MILTON MUNICIPAL UTILITY COMMISSION  
CABELL COUNTY, WEST VIRGINIA

CONTRACT #1 – MORRIS MEMORIAL SANITARY SEWER EXTENSION

ADDENDUM #1

THRASHER PROJECT #020-1526

SHEET No.  
**3**

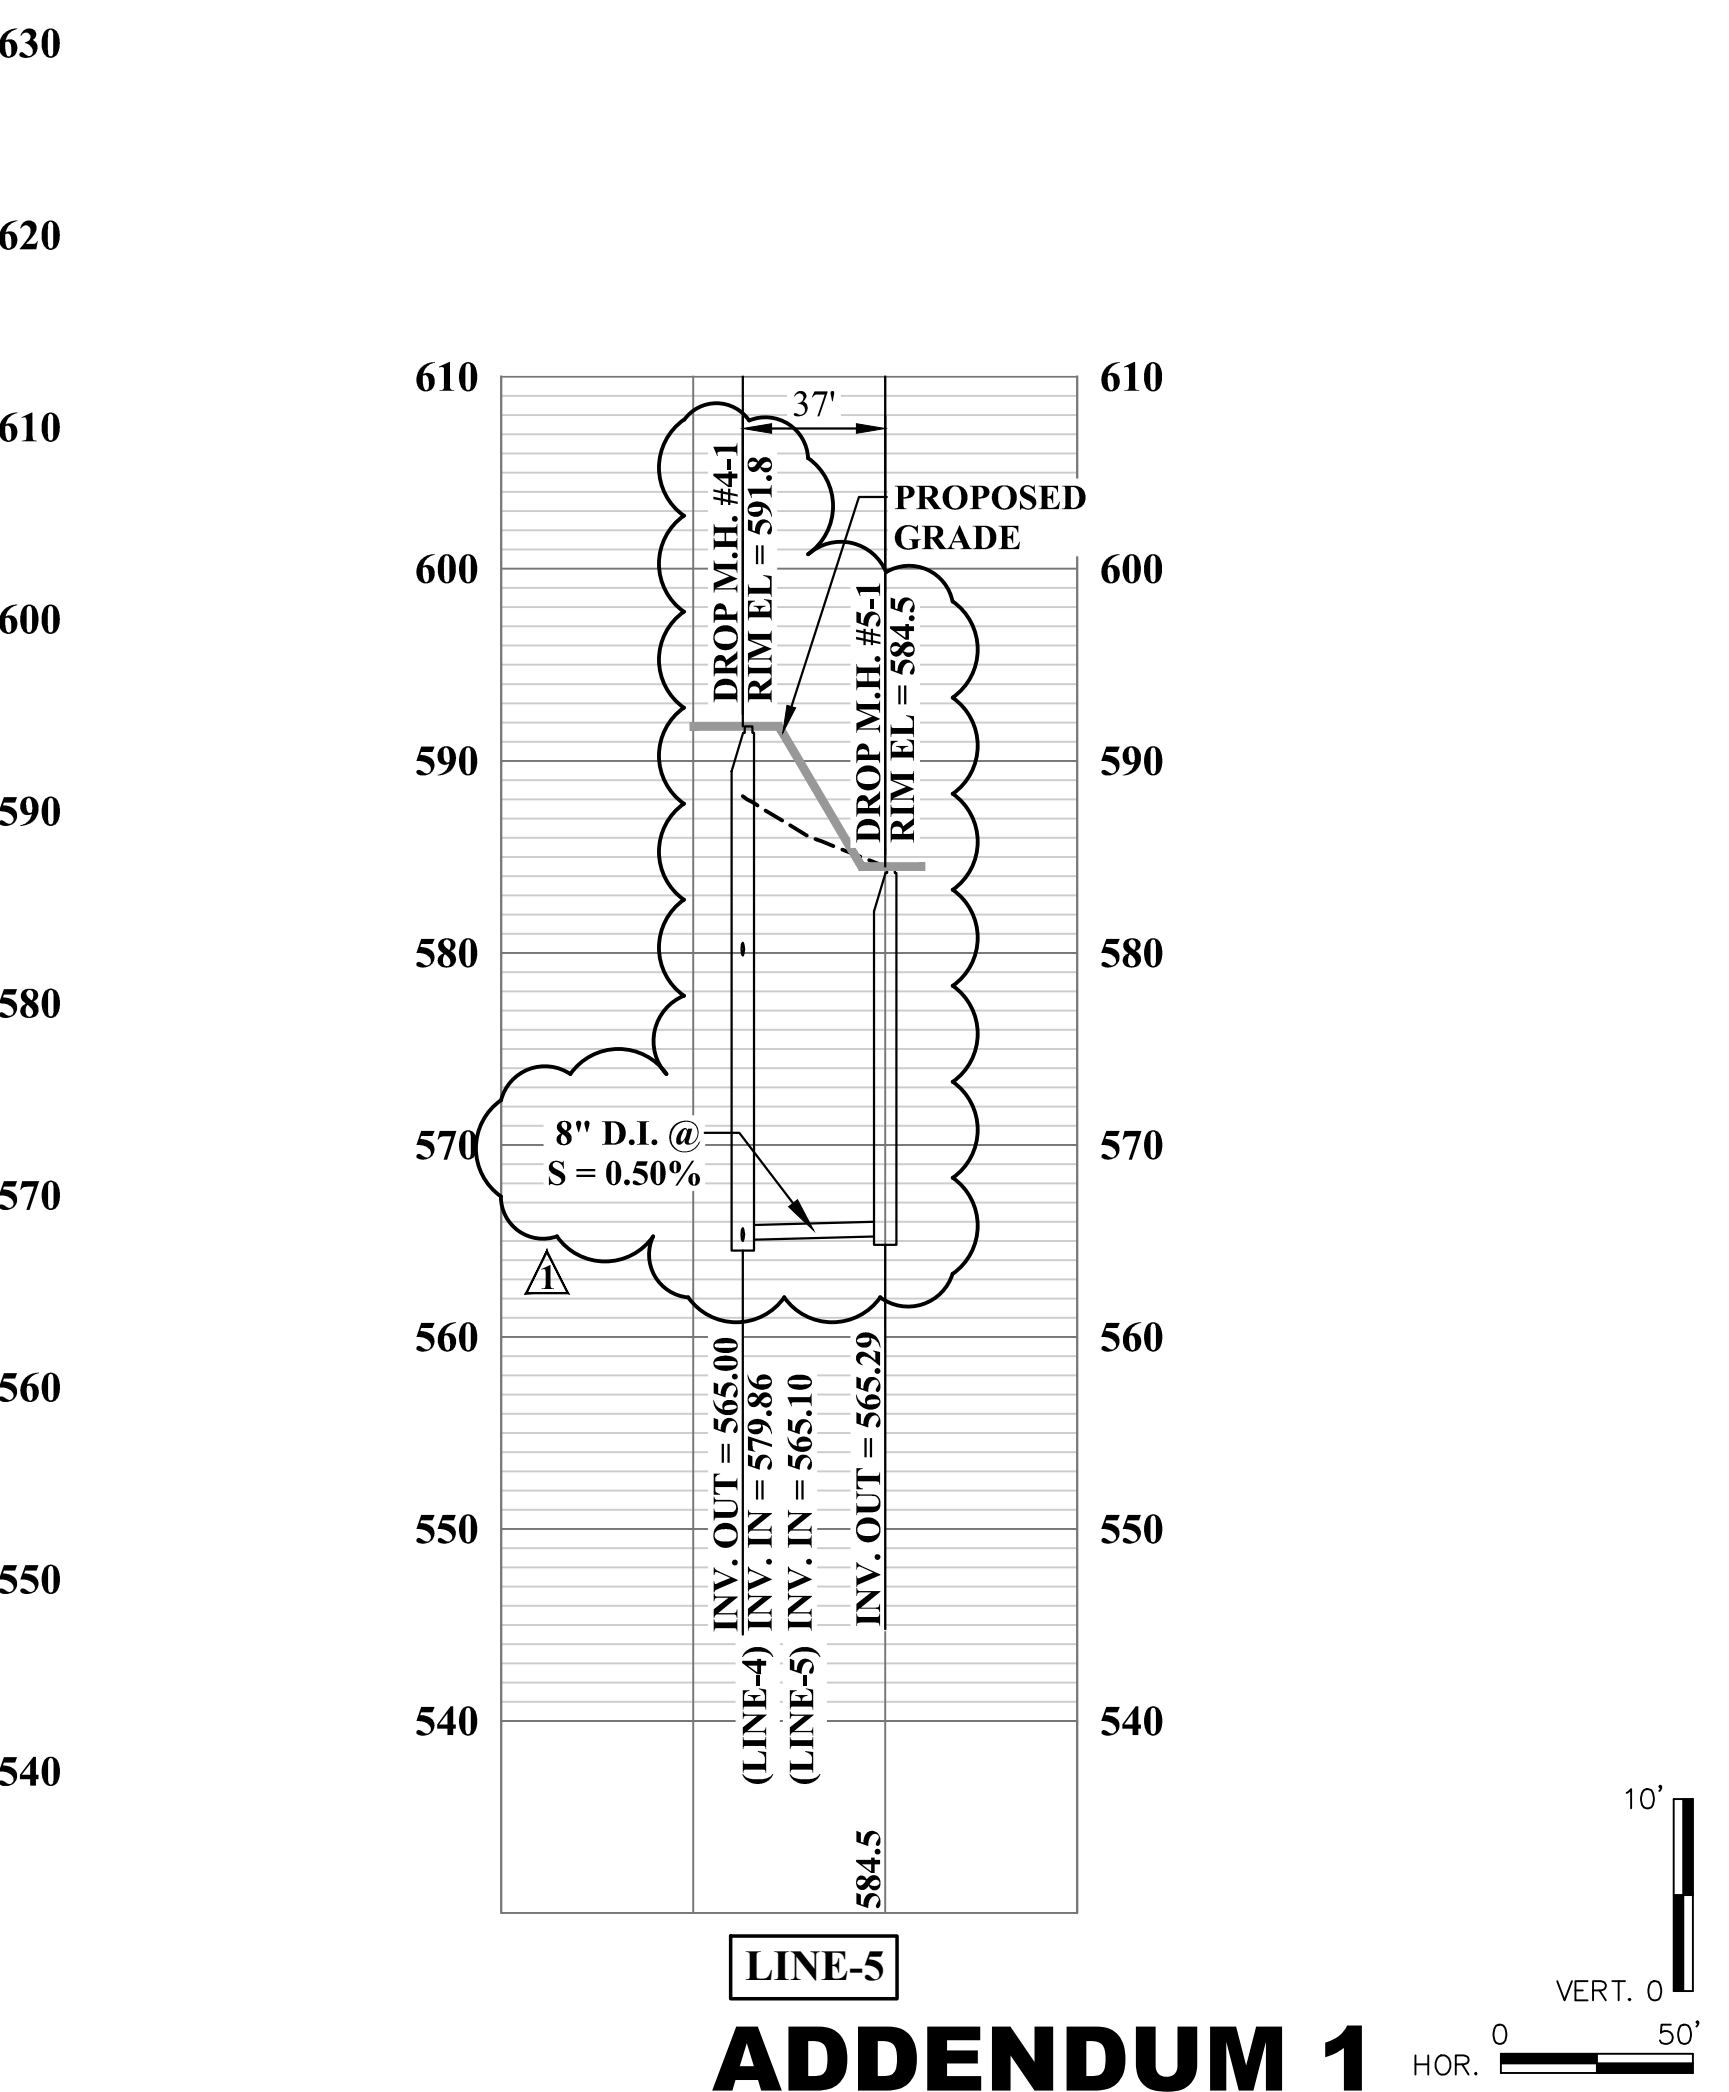
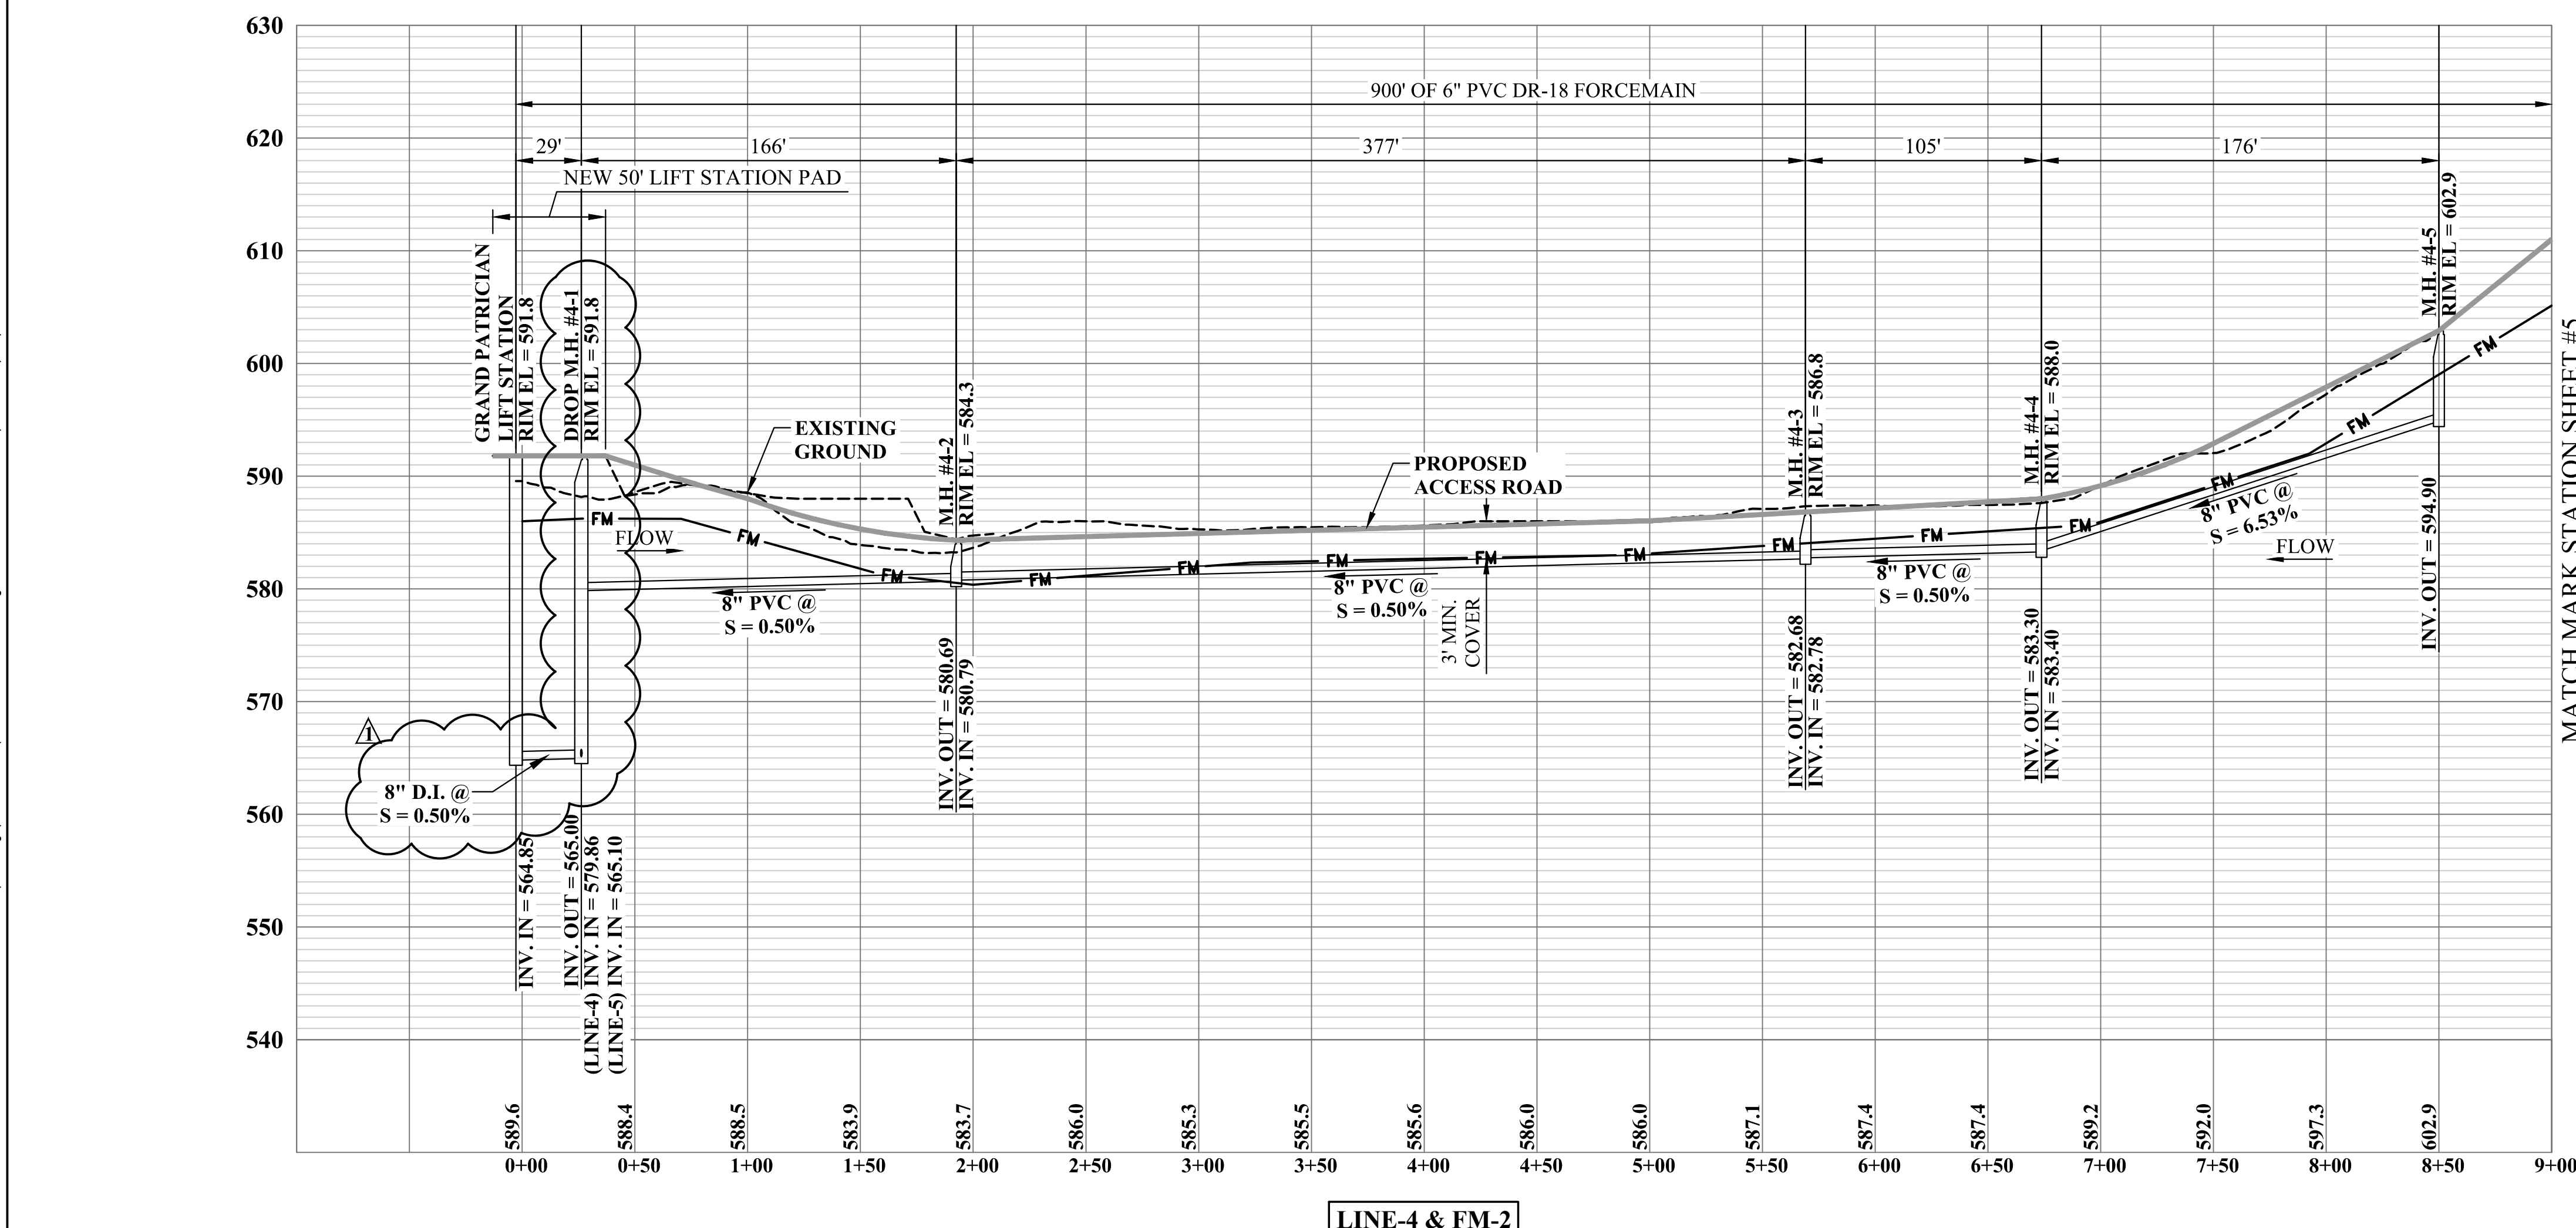
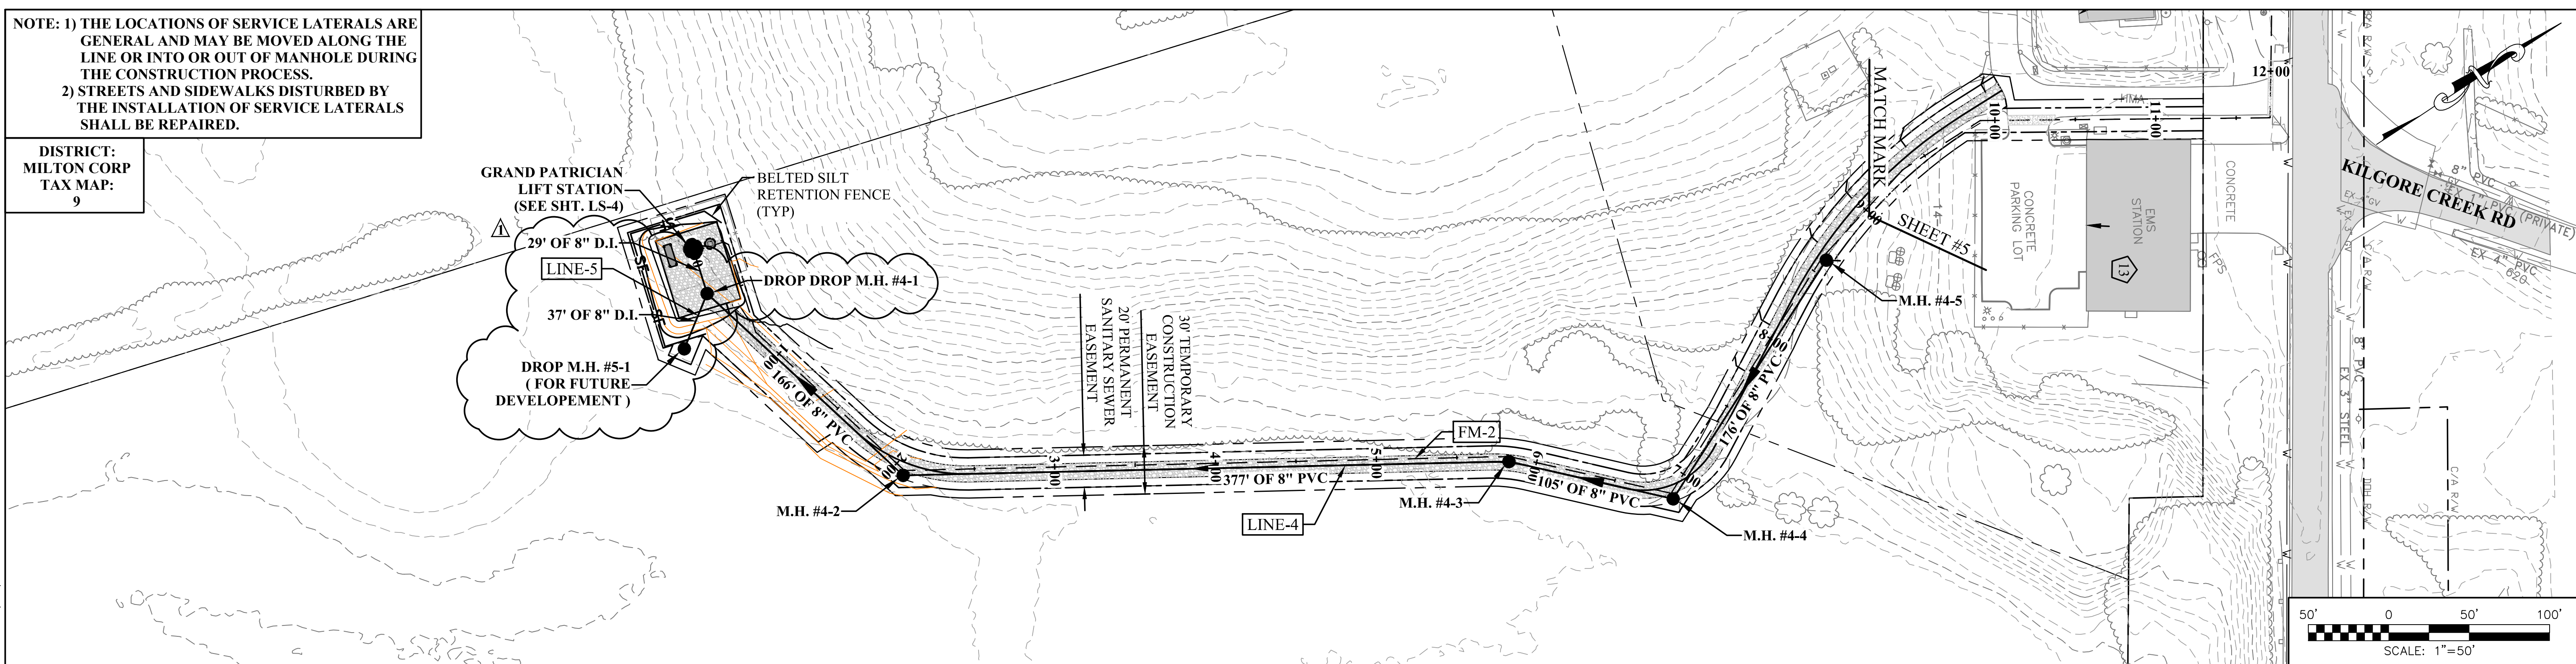
1	KMP	1/2022	ADDENDUM 1 - UPDATED LIFT STATION SITE - SEE SHEET LS-1
NO.	BY	DATE	DESCRIPTION
